**CITY OF DELAND
REGULAR MEETING OF THE PLANNING BOARD
JUNE 27, 2024 AT 5:00 PM
CITY HALL, COMMISSION CHAMBERS
120 SOUTH FLORIDA AVENUE**

**PLANNING DEPARTMENT STAFF REPORT
TO
PLANNING BOARD**

APPLICATION: PSB23-029

SUBJECT: Preliminary Plat for Towns at Summit Place

CAPE COD INSPIRED
FRONT ELEVATION

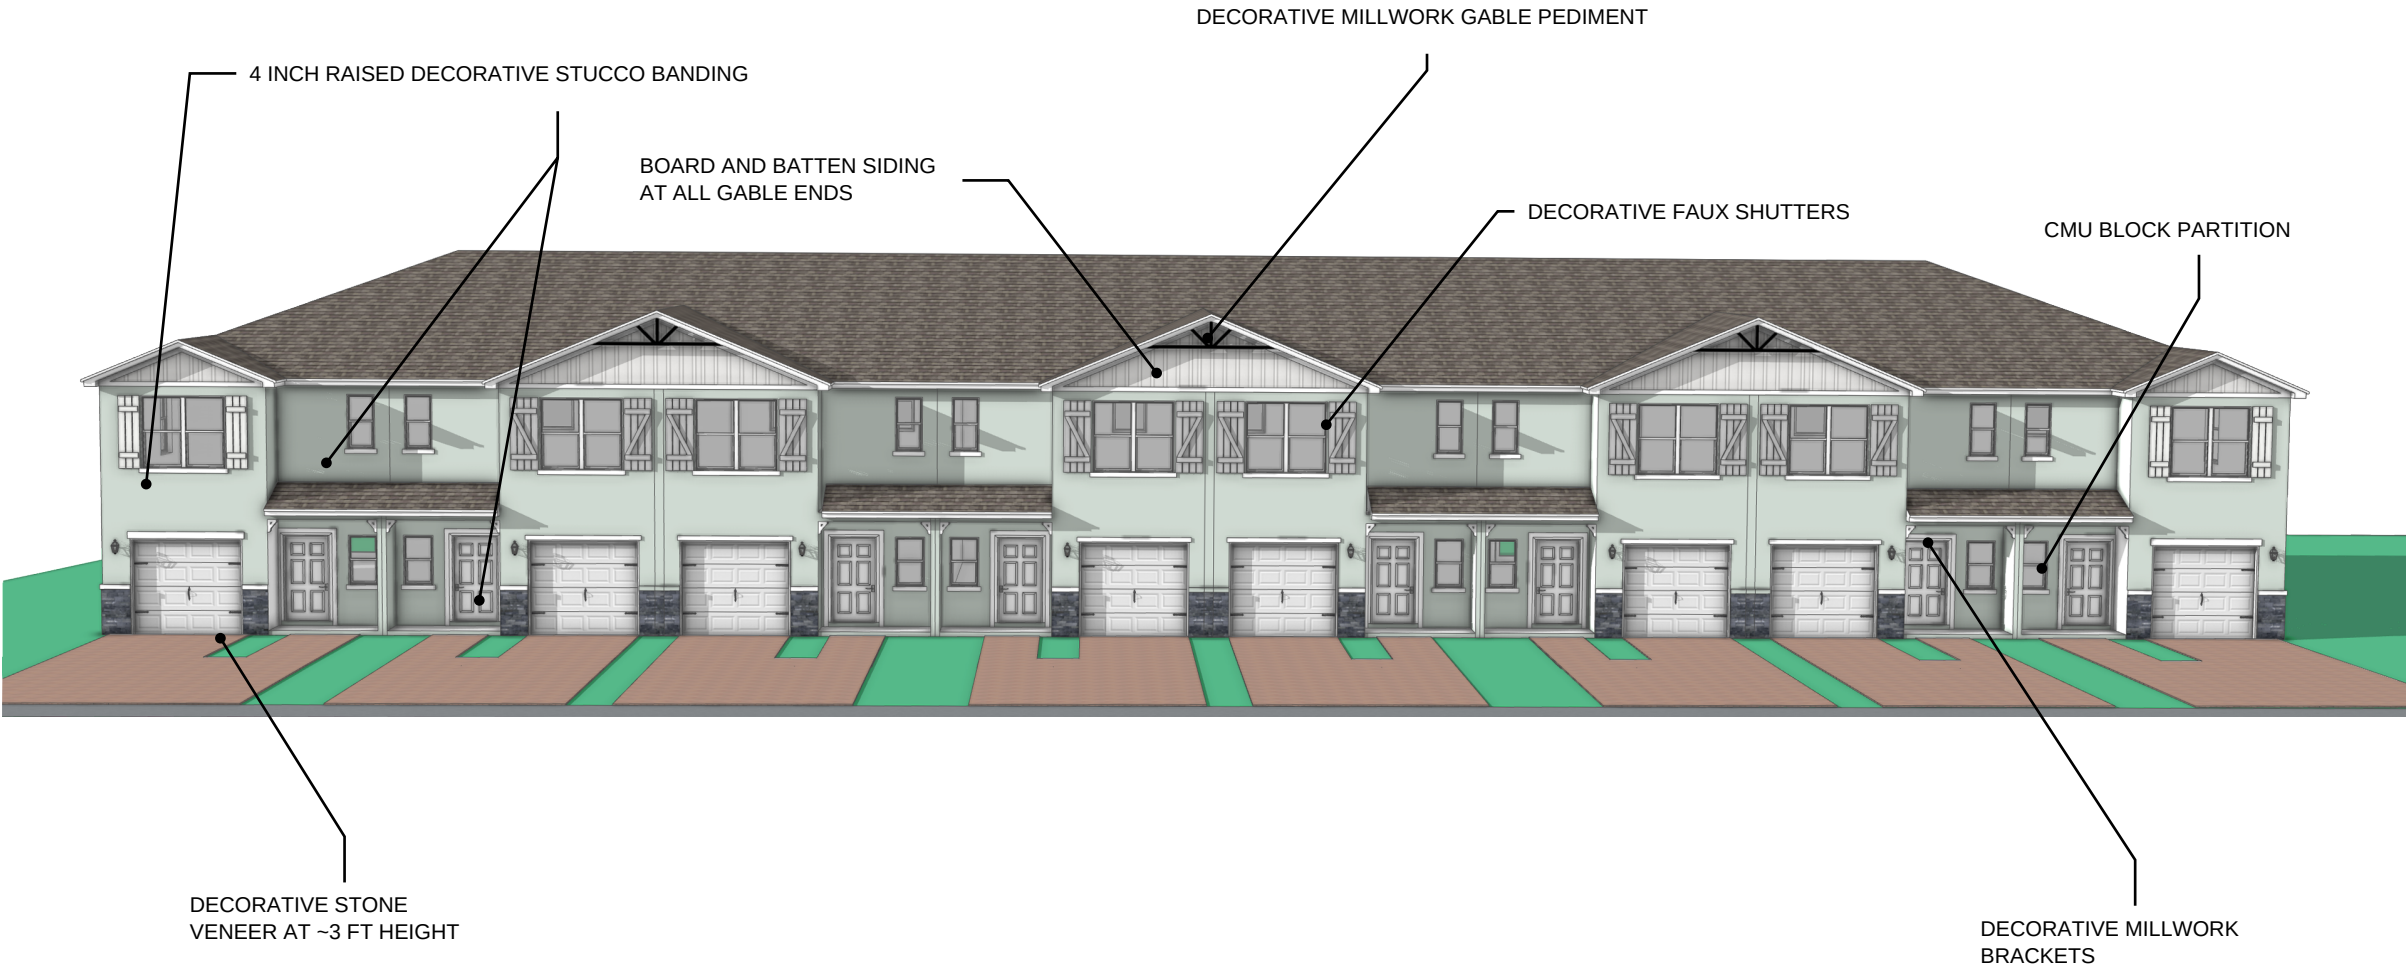
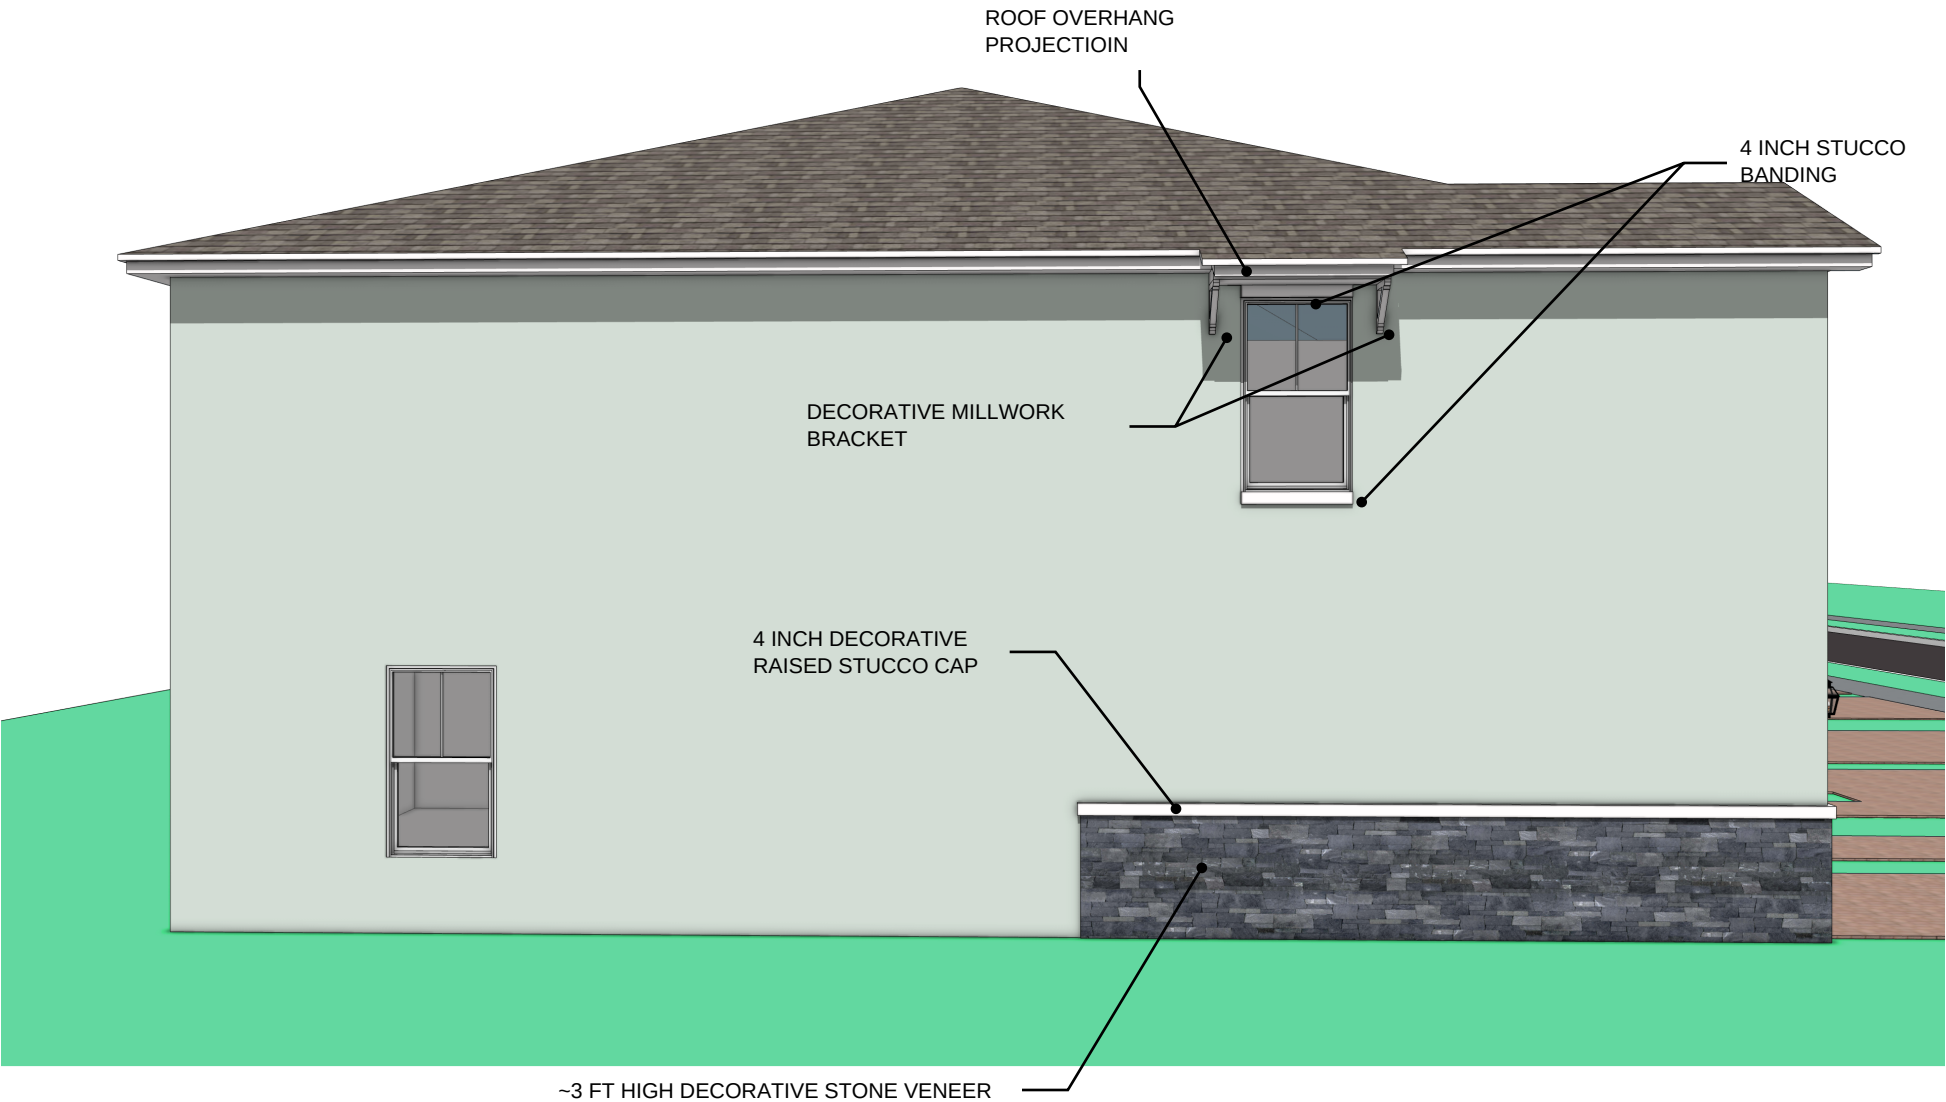
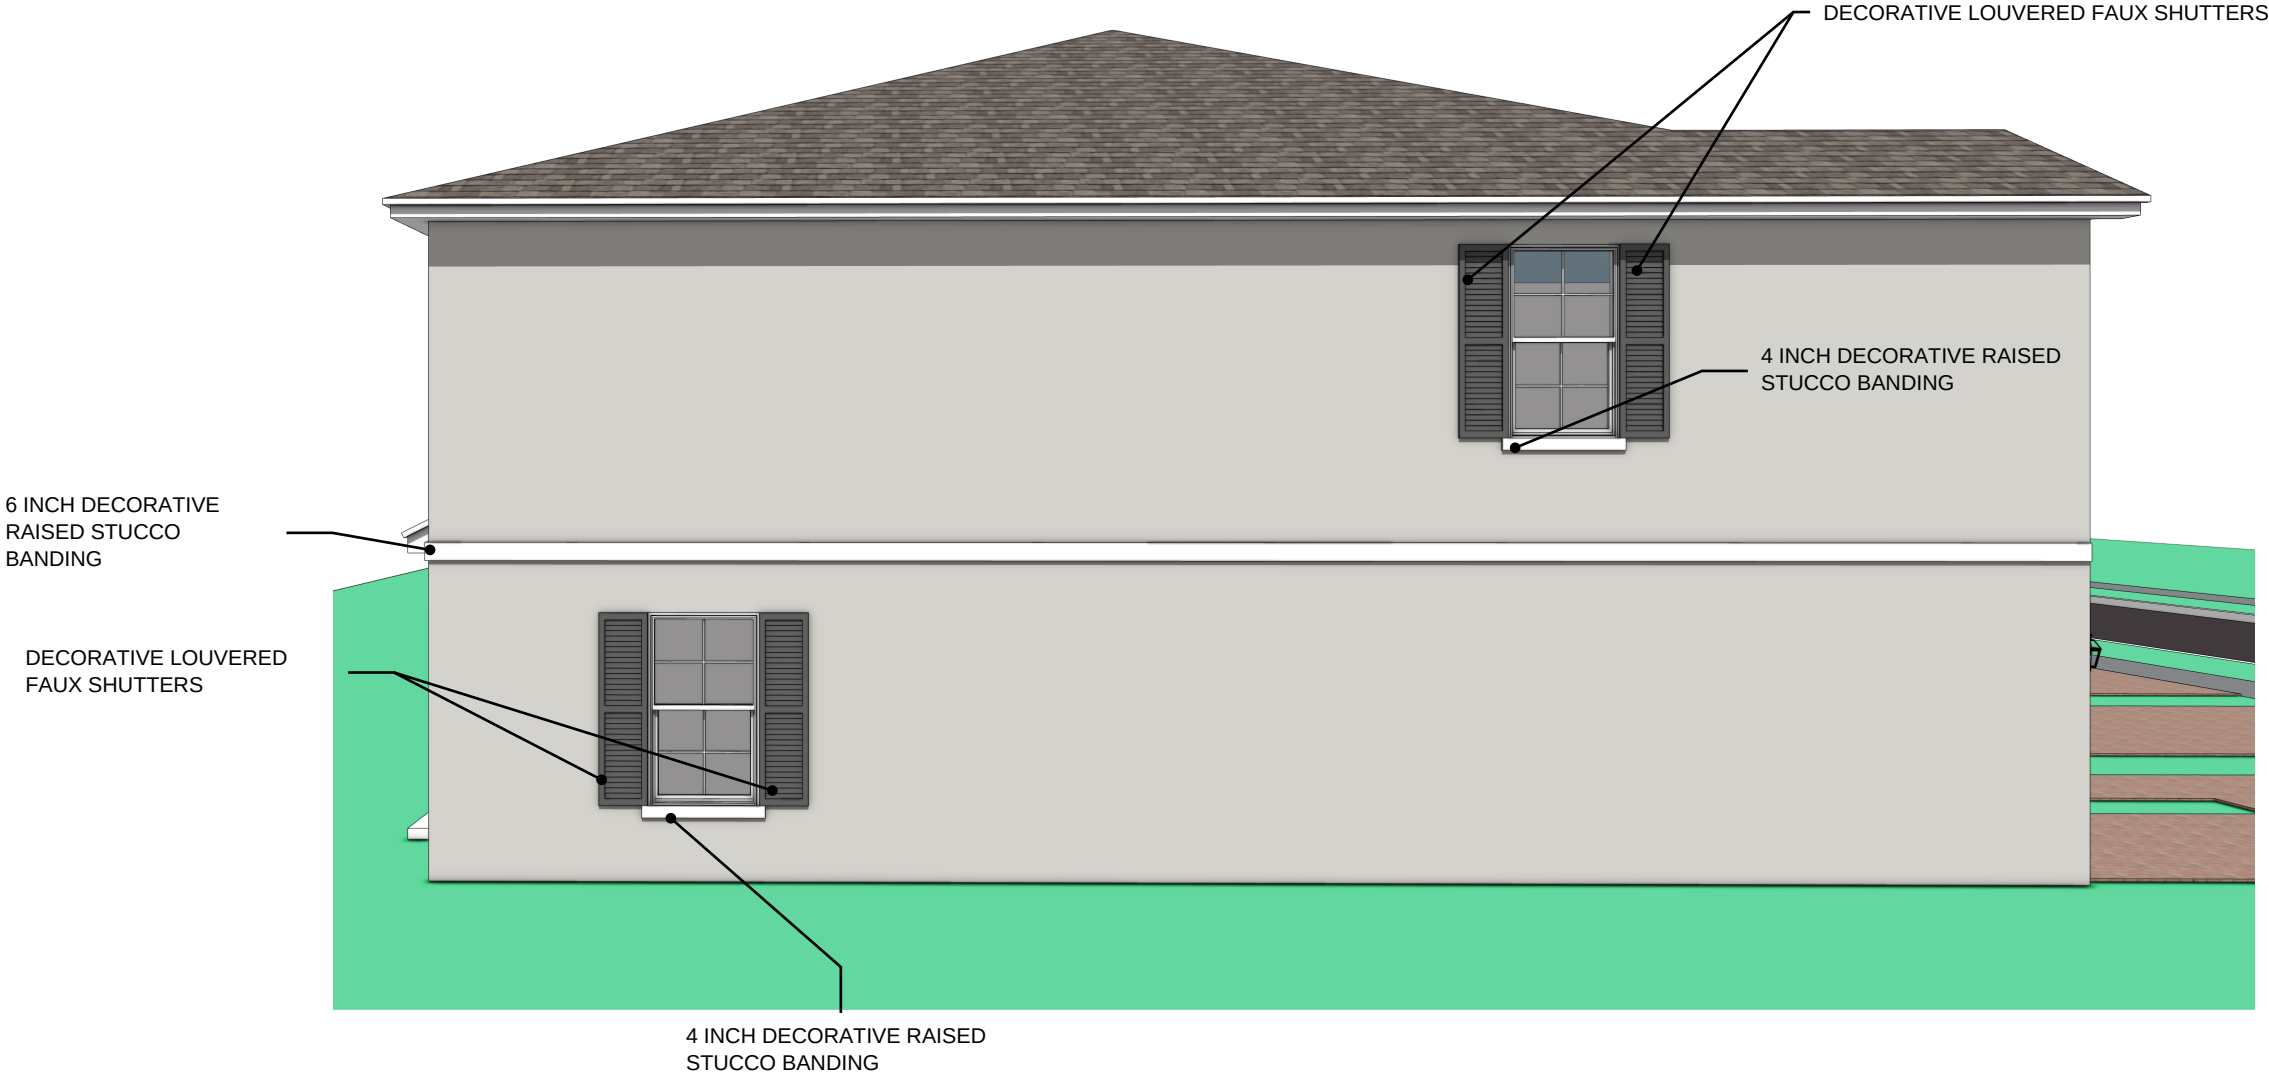
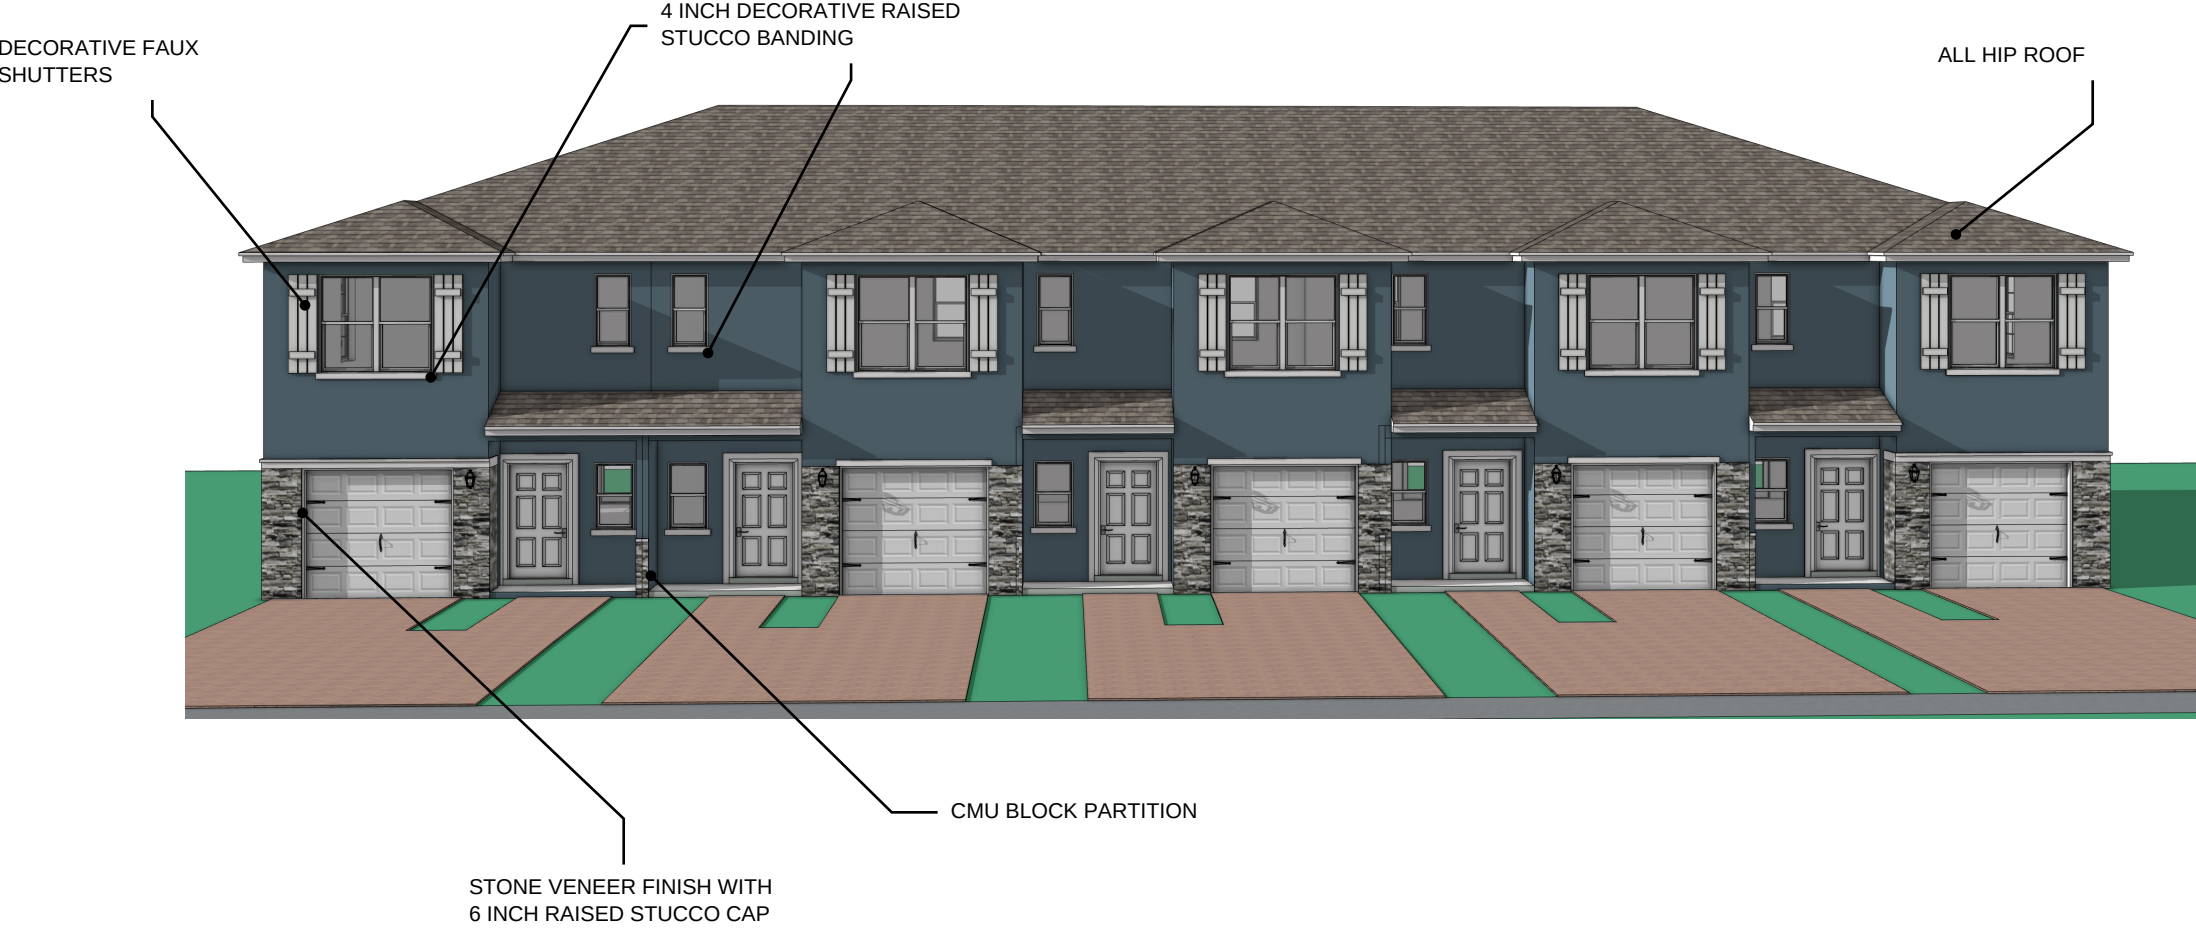
Outstanding Issues: Staff and the City's architect have reviewed the proposed elevations and find that the proposed elevations are not varied thereby creating a monotonous repetition of identical structures on a single site. The applicant has made minor changes, such as altering the shutters on the building facades, but has not adequately varied the building elevations. This monotonous repetition leads to a canyon-like feel throughout the development. The recently-approved Planned Development Agreement includes language regarding consistency with the Community Design Standards. Furthermore, the Lake Winnemissett Local Gateway Plan calls for varied architecture to reduce monotonous appearance of buildings.

Staff and the City's architect have met with the applicant to discuss the need for a variety of facades to limit or reduce the monotonous appearance. This concern has been consistently raised with the applicant since the initial sketch plan application submitted on March 9, 2023.. However, the most recent June 20, 2024 submittal does not reduce or eliminate the monotonous appearance. Staff has provided the applicant examples within the D.R. Horton product line that would address the architectural concerns.

Therefore, staff has included a condition of approval regarding the need for revised architectural elevations to be submitted and reviewed prior to scheduling this item before the City Commission. Enhanced architectural features such as varied porches, garage overhangs, front porch railings, differing materials, siding, and color changes are needed to reduce the monotonous repetition.

The applicant submitted architectural elevations and plans on June 20, 2024 addressing some of remaining staff comments from the June 12, 2024 Planning Board meeting, but staff finds that these architectural elevation revisions do not provide enough variety in materials, rooflines, and façade enhancements to reduce the monotony.

1. All outstanding TRC comments shall be addressed to the satisfaction of City Staff (forestry) prior to scheduling this item for City Commission review.
2. Updated architectural elevations complying with staff recommendations that remove the monotonous appearance and include a variety of materials, colors, and wall plane variation shall be submitted to and signed of by city staff prior to scheduling this item for City Commission consideration.
